Brightview Bethesda: Sketch Plan 320160010 and Preliminary Plan 120160010

Staff Report Date: 11/25/2015

- Two lots for an assisted living facility consisting of up to 120 dwelling units and 3,125 square feet nonresidential uses in an eight-story building and retention of an existing office building;
- Located in the northeast quadrant of the intersection of Rugby Avenue and Glenbrook Road in the Bethesda CBD;
- 1.39 gross acres zoned CR 3.0 C 1.0, R 2.75, H 90 T and CRN 0.5 C 0.5, R 0.25 H 35
- Woodmont Triangle Amendment to the Bethesda CBD Sector Plan* area;
- Application accepted July 23, 2015;
- Applicant: Shelter Development, LLC.
- Review Basis: Chapter 50 and Chapter 59

- Staff recommendation: Approval of the sketch plan and preliminary plan amendment.**
- The project is being developed with the use of FAR Averaging (density transfer) from two sending properties. The density transfer will send 19,000 square feet of residential floor area from the sending sites to the subject property.

Attachment E: Shadow Study

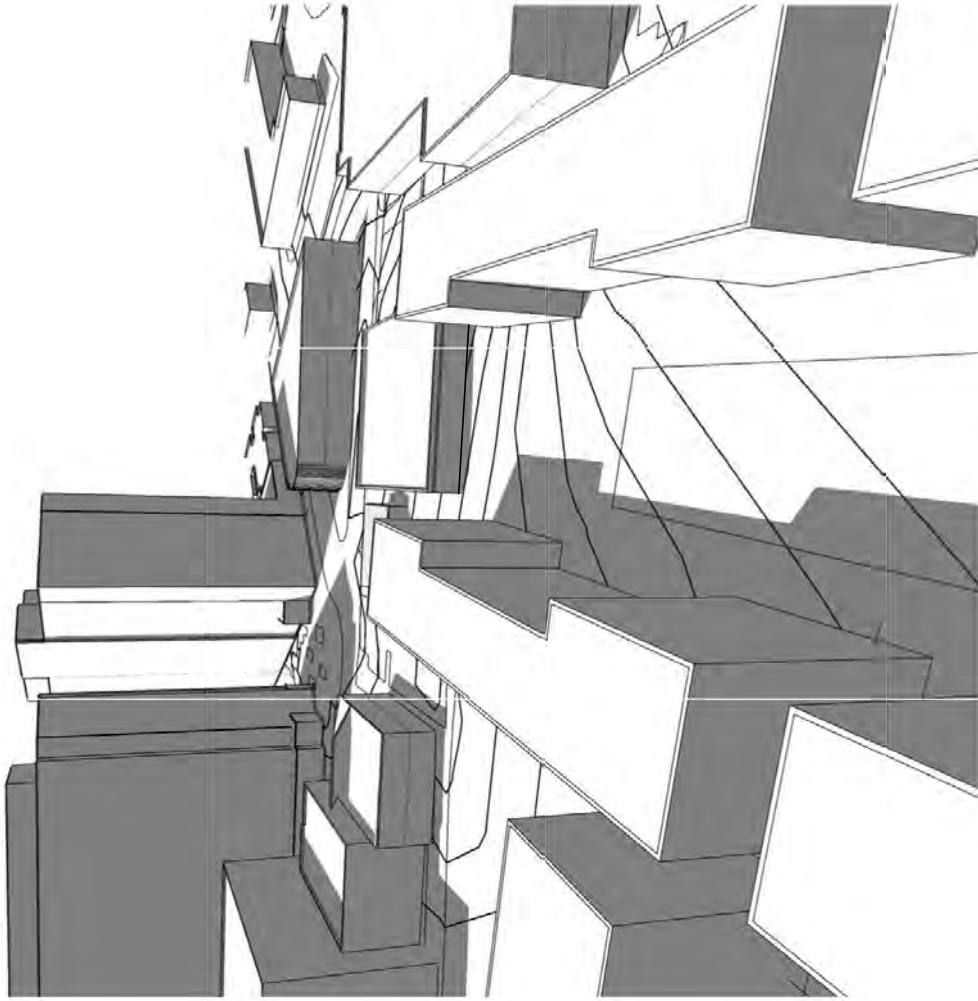
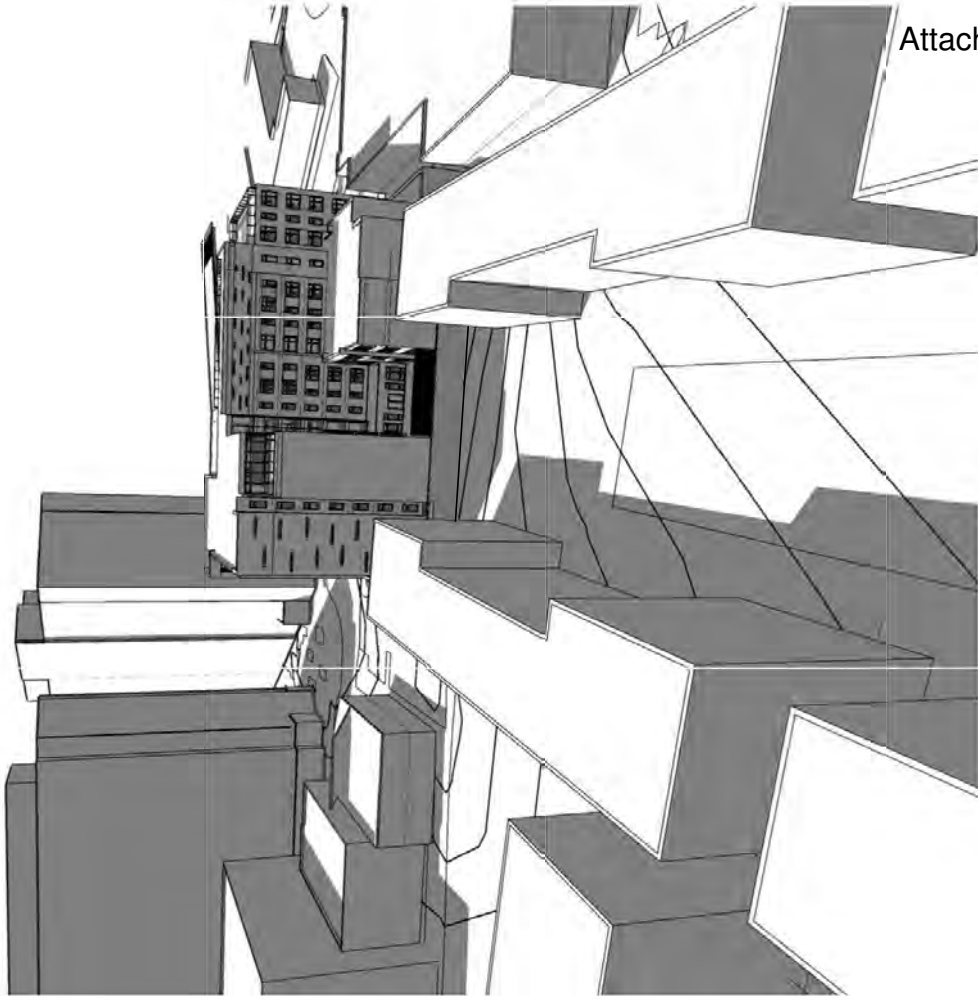
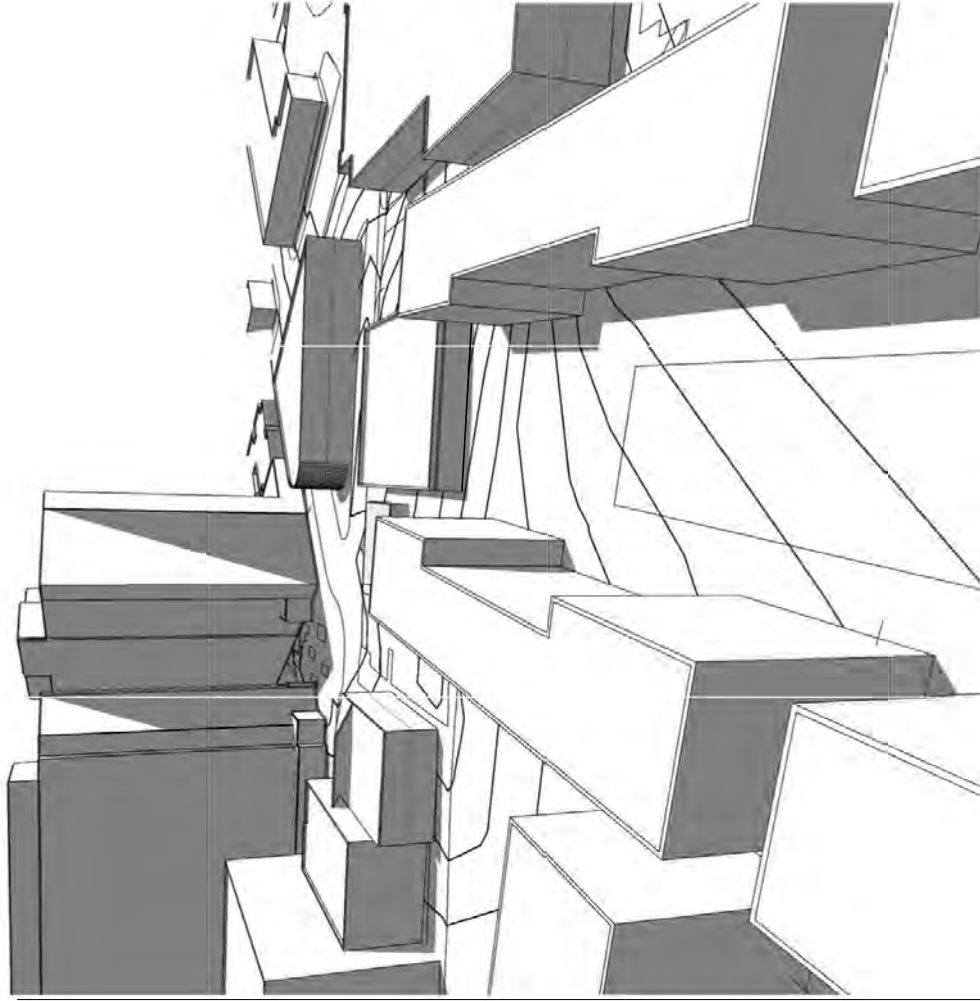
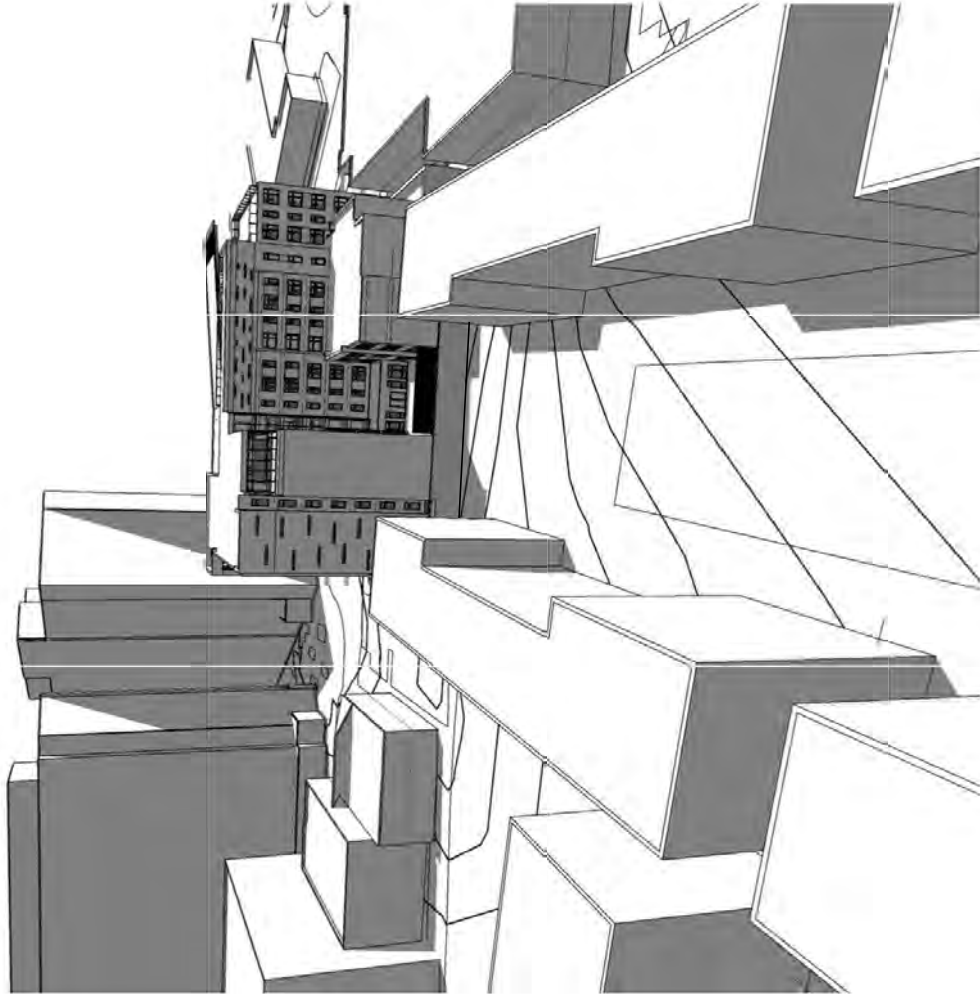
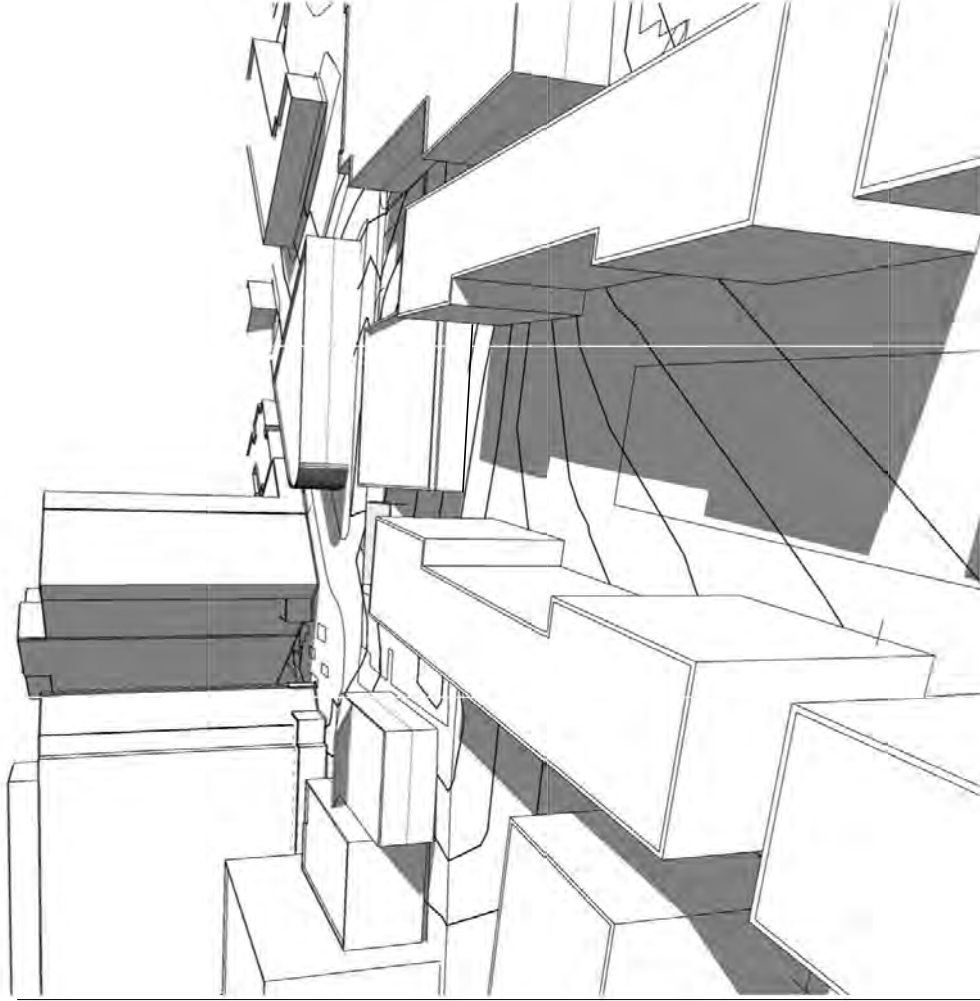
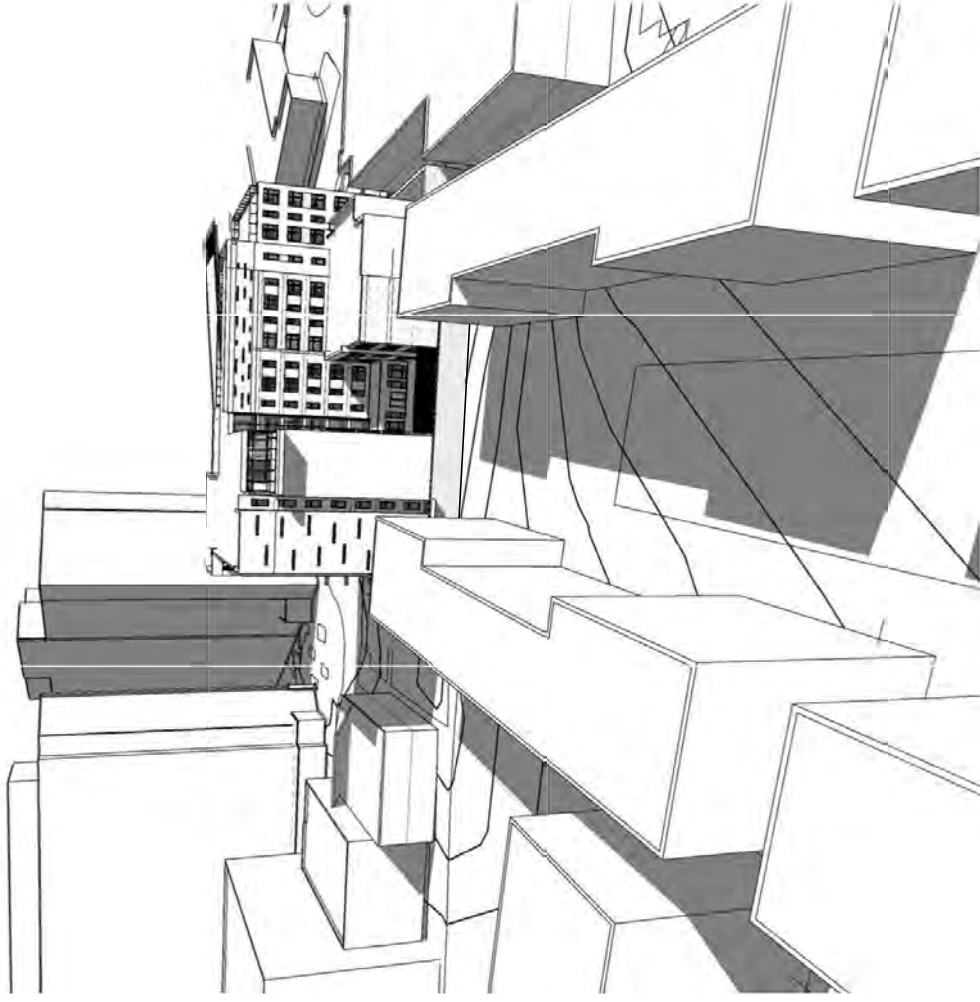
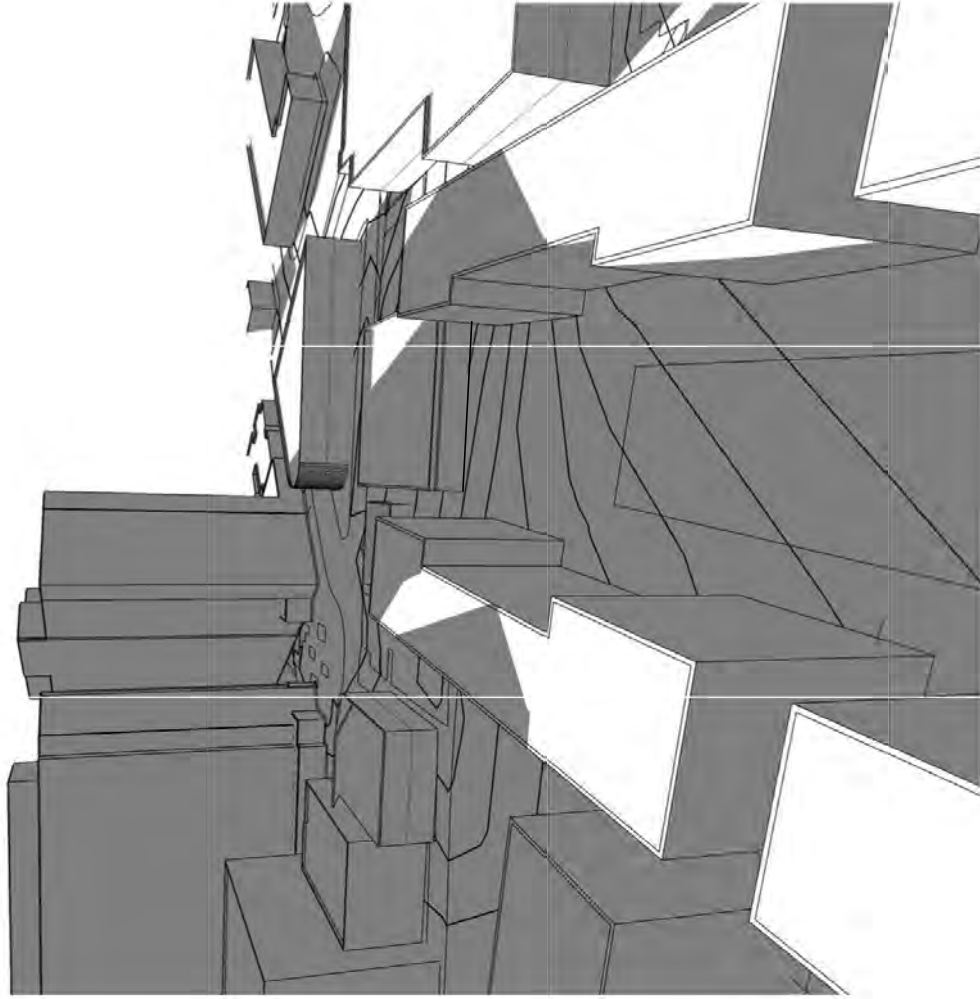
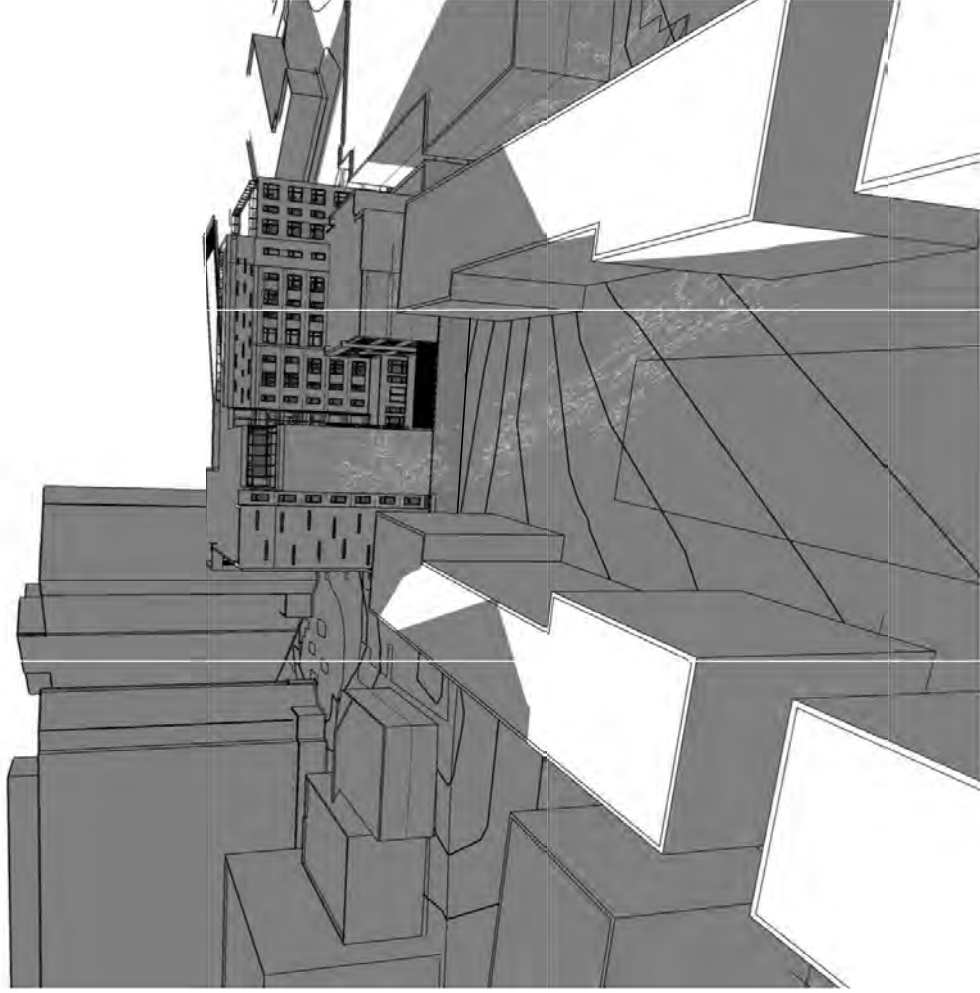
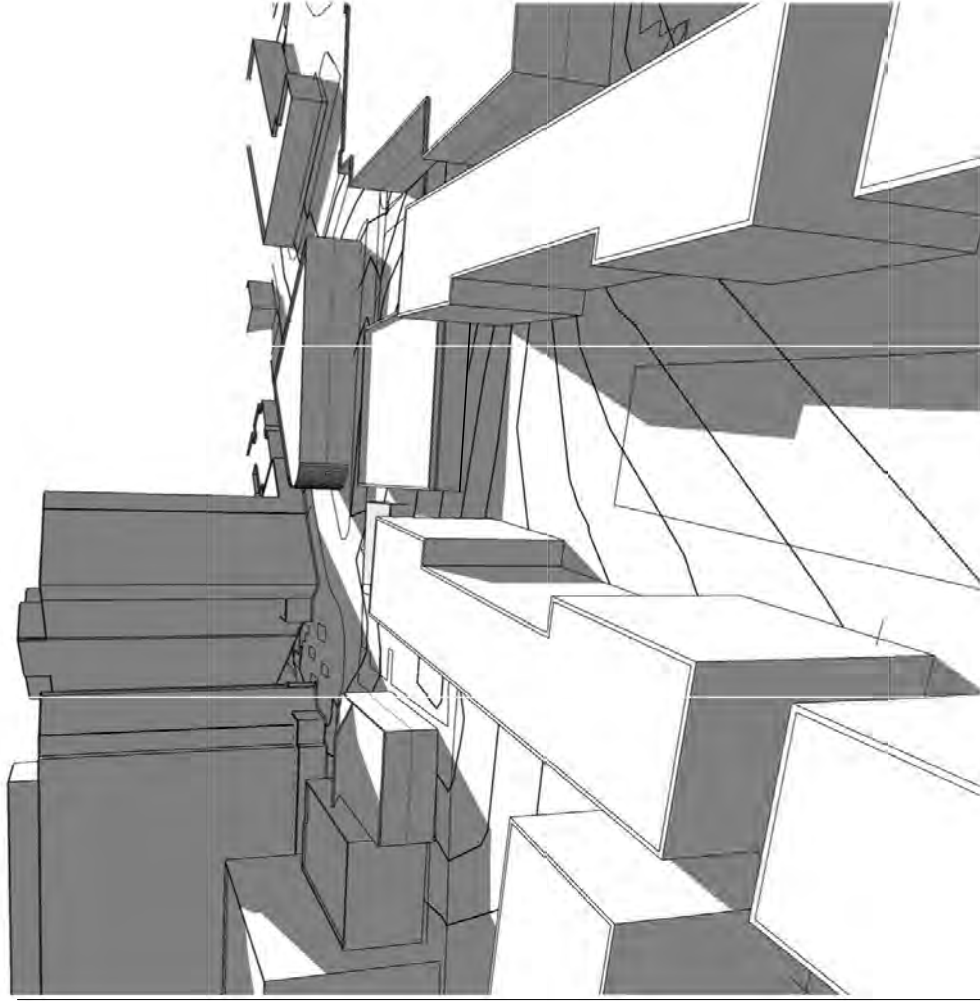
The applicant has complied with all submittal and noticing requirements. As of the date of this staff report, staff has received one letter on the application (Attachment D). The letter, from the managing member of the company that owns an adjacent garden apartment complex, raised concerns about the proposed building's potential to create excessive shadows on the garden apartment property. In response to the letter, staff requested that the applicant provide a shadow study for the project (Attachment E). As discussed below, the shadow study shows that construction of the proposed building will not substantially increase the amount of shadow that is cast onto the garden apartment property.

That would simply be unfair. The economic value of our property would be severely compromised – it is likely that we would be unable to rent at least half of our apartments for anything close to the already very low rents we are charging for them now. How many tenants do you think would want to rent an apartment at all that would be rendered into virtual darkness for so much of the day and so much of the year?

We have met with the architect of the project – a nice person who has tried to placate us by getting the developer to lower one side of the building by one floor. But that will not suffice – the building is too big as proposed. I am confident that one property owner is not permitted to drastically reduce the economic value of a neighboring property. So I ask that you deny this application as submitted – perhaps Brightview can develop a better plan that would not so drastically affect our property.
